**August 23, 2024**

**The Reserves at Grand View Heights – Proj 22-3262**

**ADDENDUM NO. 2**

A5.1

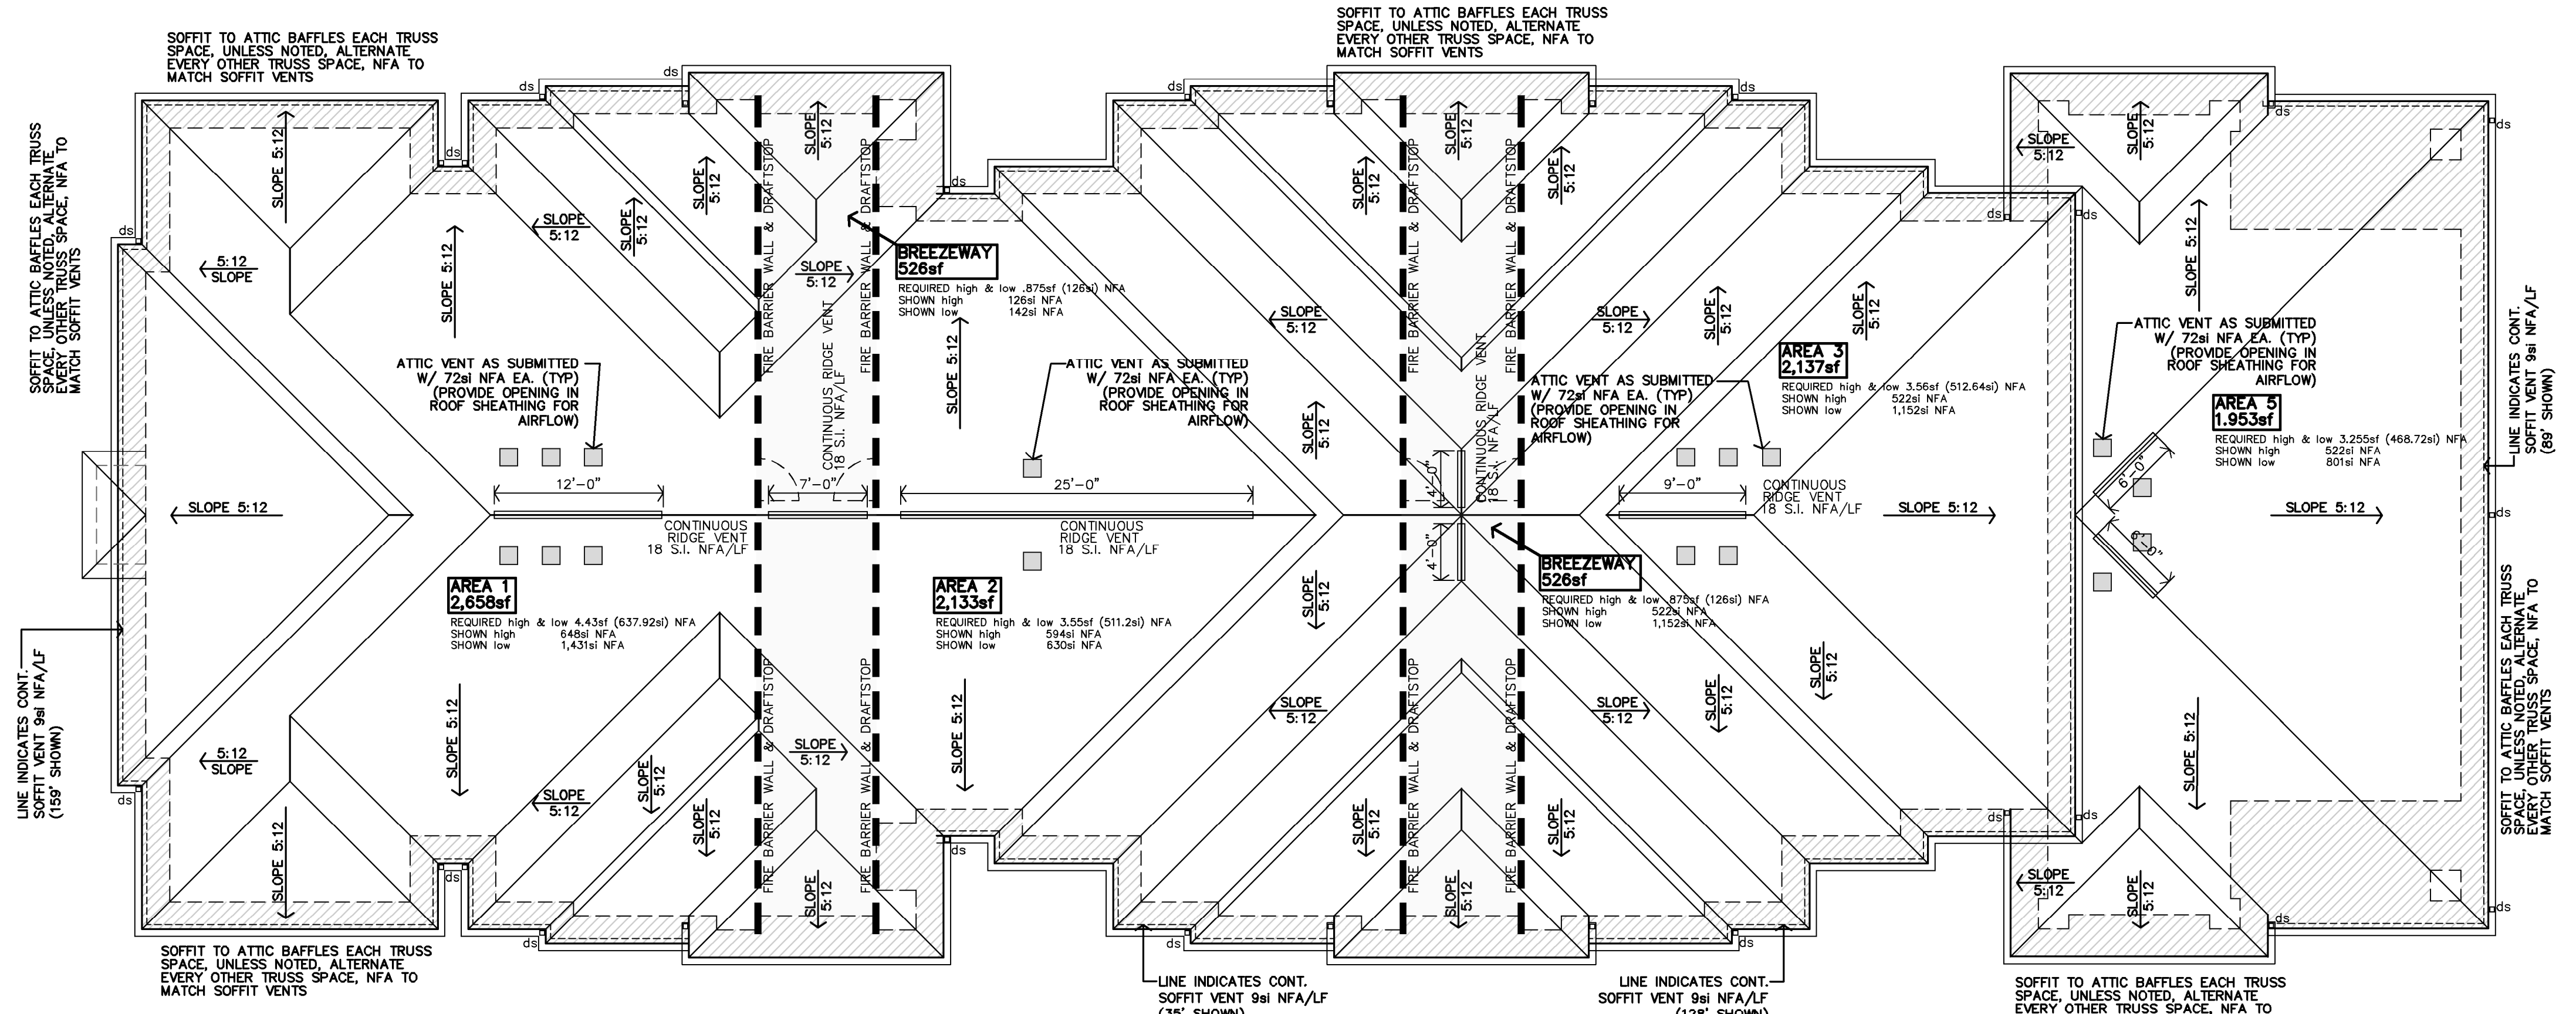
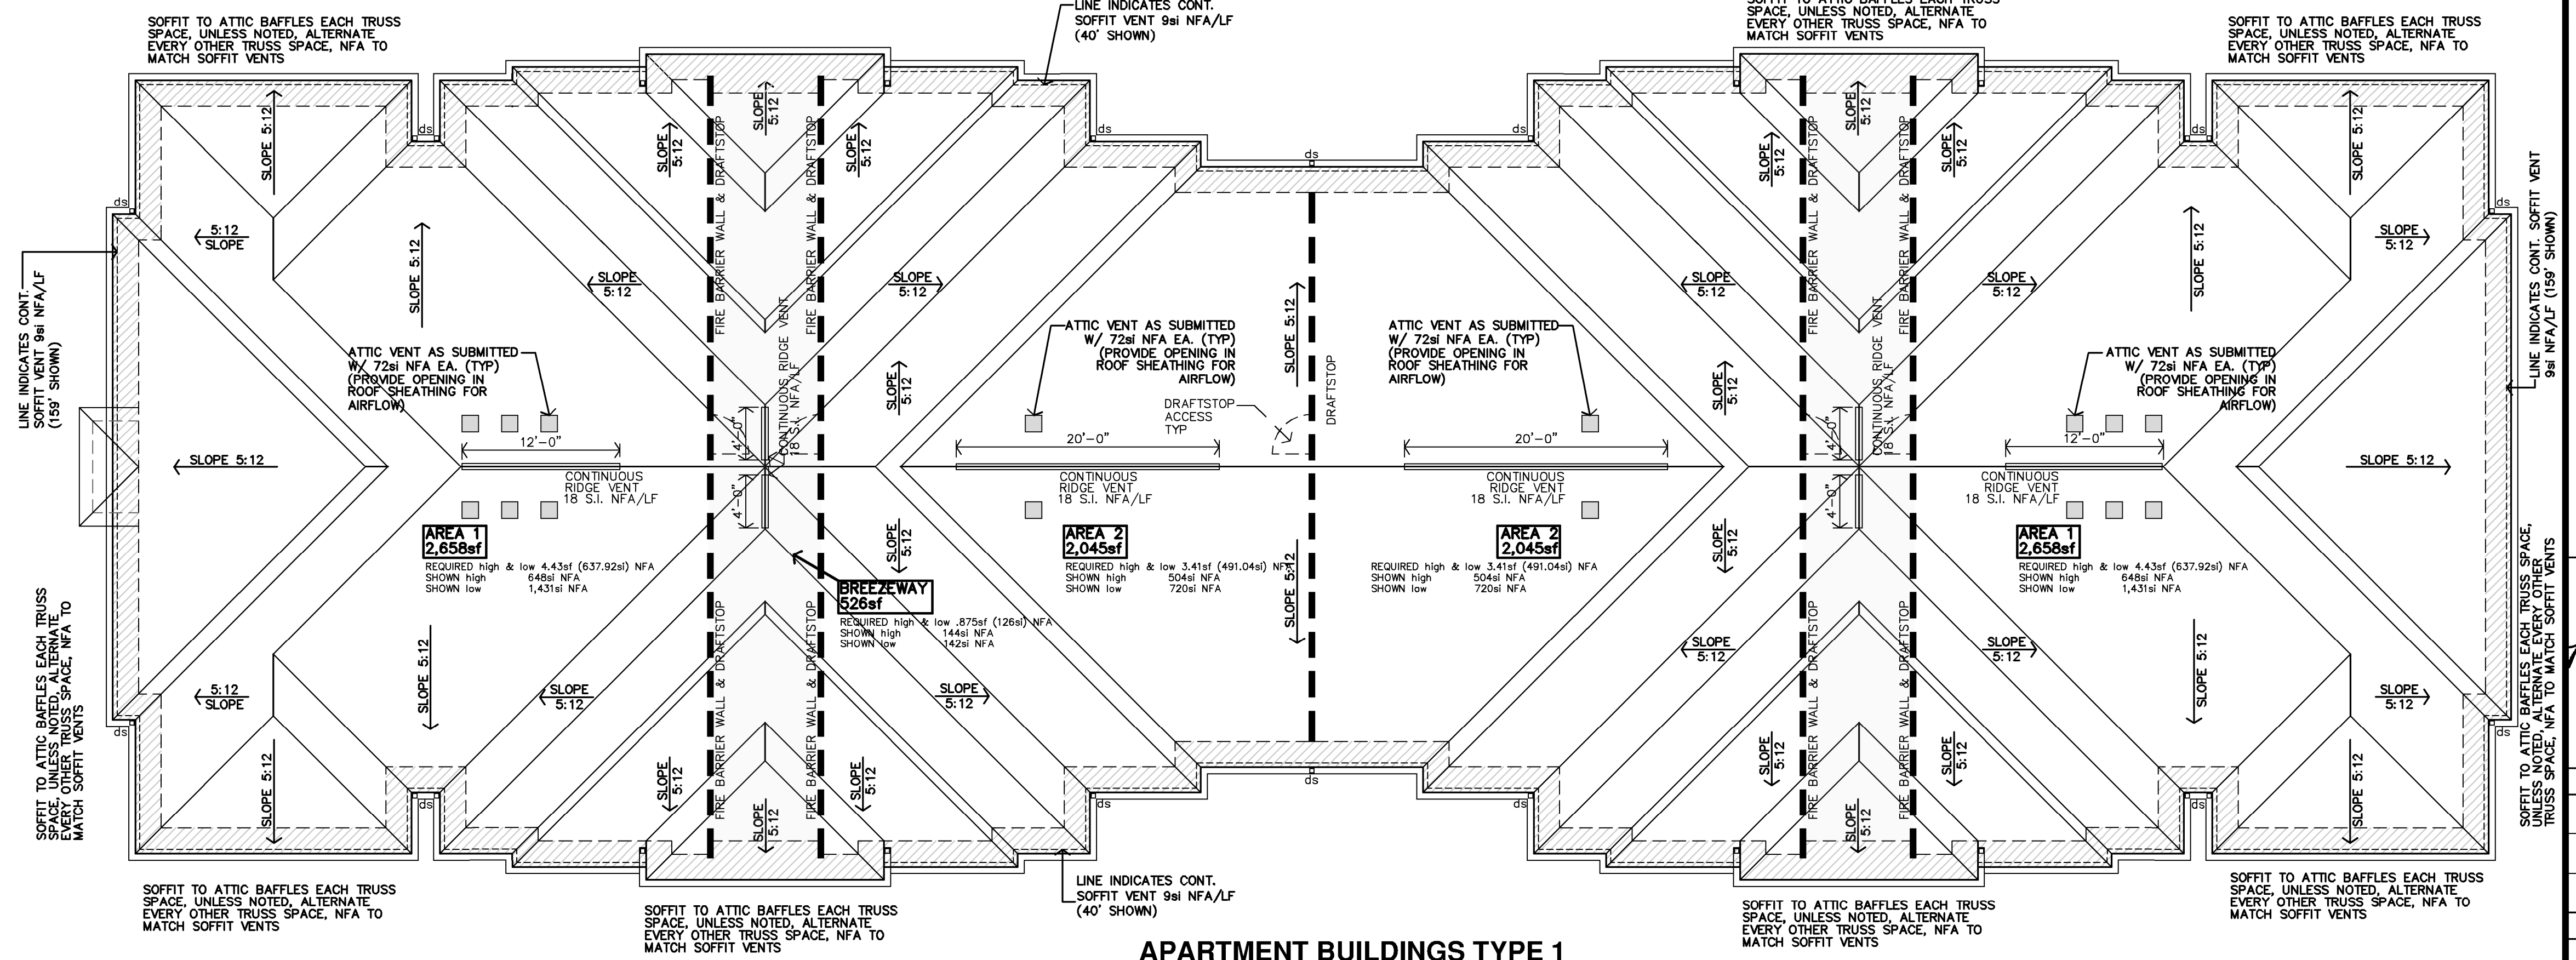
1. Sheet A5.1
  - a. Add Sheet Number to page – A5.1
  - b. Roof General Notes
    - i. Note 4 – IBC reference has been corrected to read “2021”
    - ii. Note 5 – Detail reference has been corrected to read “H-A4.5”
    - iii. Note 7 – Delete
    - iv. Note 8 – Roof slope corrected to read “5:12”
    - v. Note 9 – IBC reference has been corrected to read “2021” and detail reference has been corrected to read “J-A4.5”
    - vi. Note 10 – IBC reference has been corrected to read “2021”
    - vii. Note 12 – Delete
  - c. Typical Soffit Material
    - i. Composite Board Ceiling – IBC reference has been corrected to read “2021”
    - ii. Deleted Composite Board Ceiling, typ. Type and Roofing Membrane Type
